AMENDMENT NO. 56 TO FACILITY OPERATING LICENSE NO. DPR-31

AMENDMENT NO. 48 TO FACILITY OPERATING LICENSE NO. DPR-41

SAFETY EVALUATION BY THE OFFICE OF NUCLEAR REACTOR REGULATION
RELATED TO AMENDMENT NO. 56 TO FACILITY OPERATING LICENSE NO. DPR-31
AND AMENDMENT NO. 48 TO FACILITY OPERATING LICENSE NO. DPR-41

FLORIDA POWER AND LIGHT COMPANY
TURKEY POINT PLANT, UNIT NOS. 3 AND 4
DOCKET NOS. 50-250 AND 50-251

FIGURE 3.1-1c: TURKEY POINT UNIT 3 REACTOR COOLANT HEATUP LIMITATIONS APPLICABLE FOR PERIODS FROM 5 TO 10 EFFECTIVE FULL POWER YEARS.

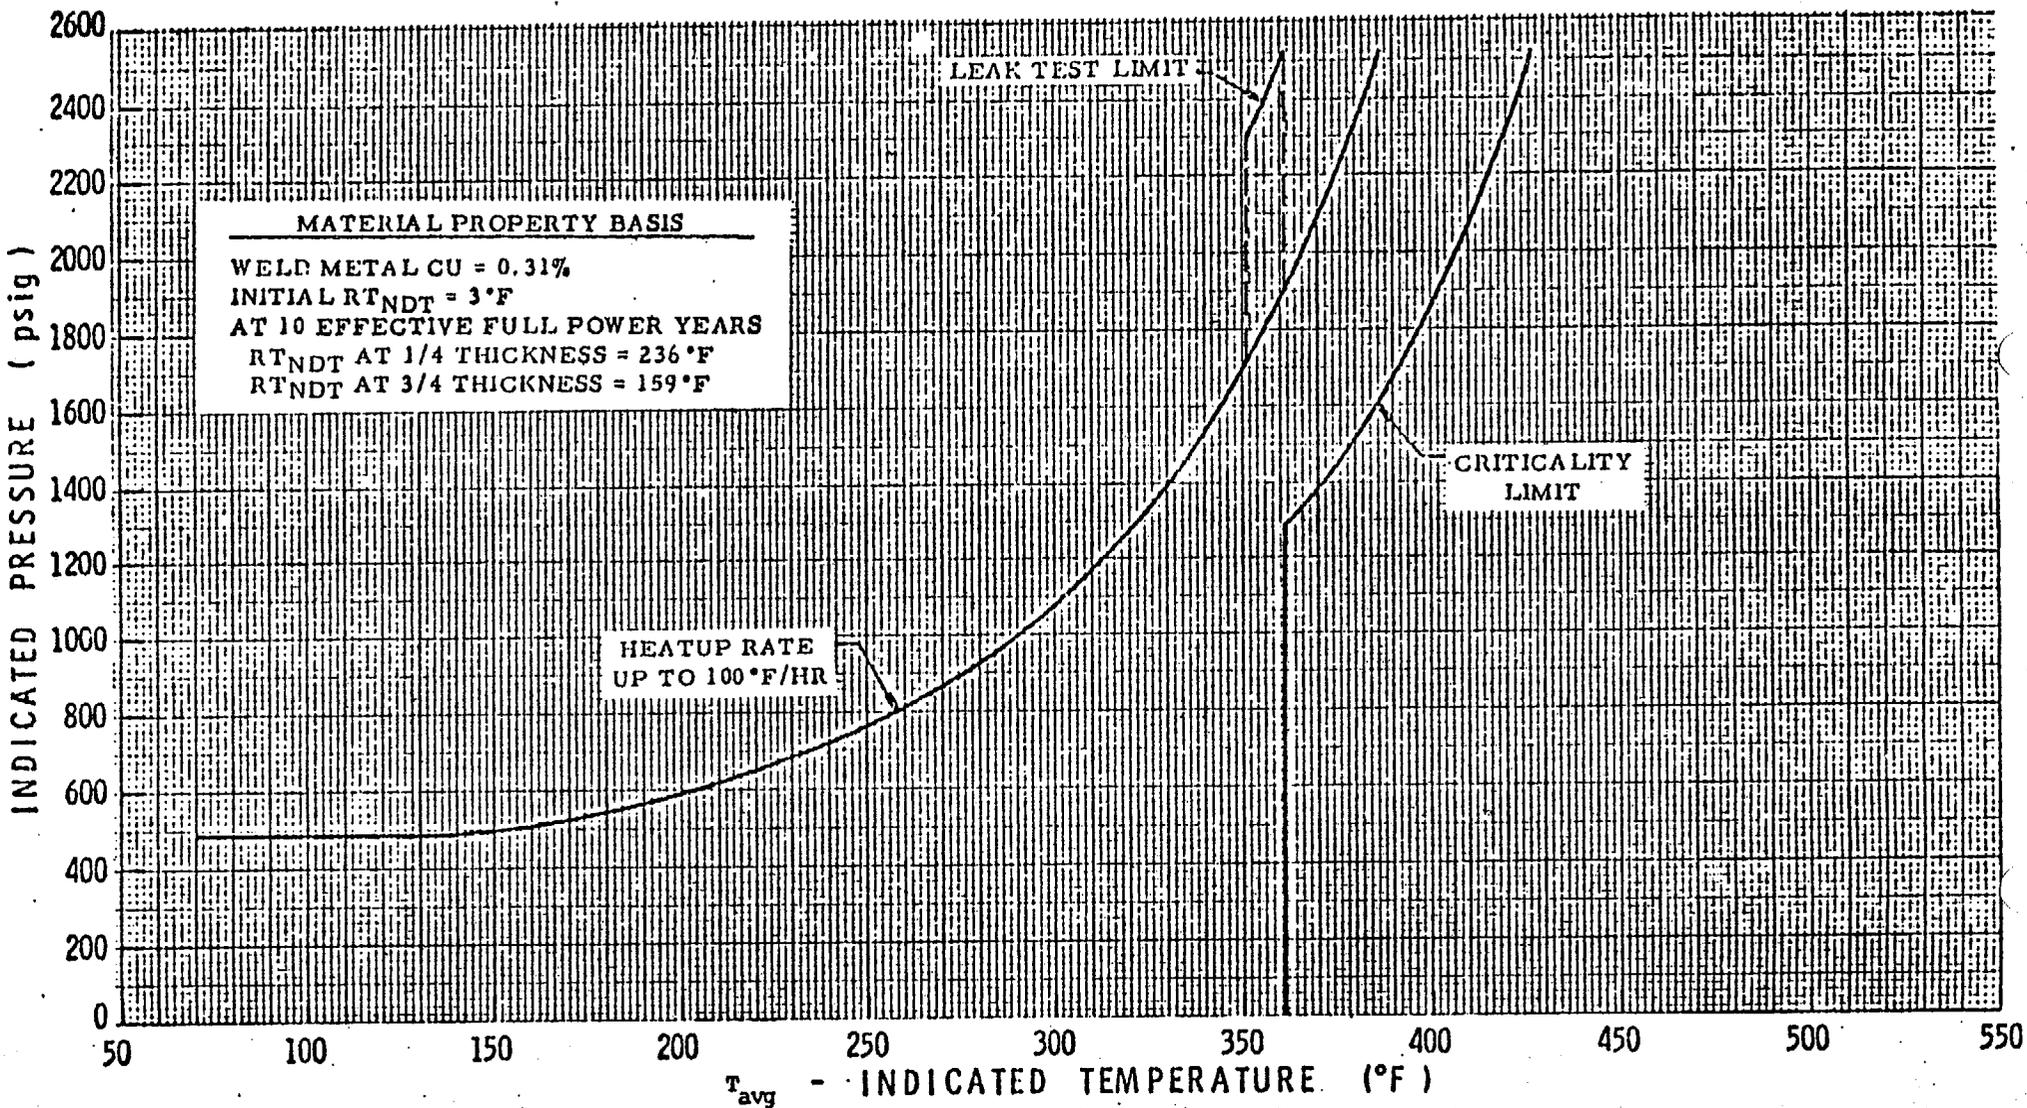
These amendments revise the reactor coolant pressure-temperature limits to account for neutron irradiation induced increases in reactor vessel metal and ductility temperature.

Revise Appendix A as follows:

Figure 3.1-1c
Figure 3.1-2c
Figure 3.1-1d
Figure 3.1-2d

From our review we conclude that the proposed pressure-temperature operating limits for Turkey Point 3 and 4 are acceptable for operation through 10 EFPY and are in accordance with Appendix G, 10 CFR Part 50 for this operational period. Compliance with Appendix G in establishing safe operating limitations will ensure adequate safety margins during operation, testing, maintenance and postulated accident conditions and constitute an acceptable basis for satisfying the requirements of NRC General Design Criterion 31, Appendix A, 10 CFR Part 50.
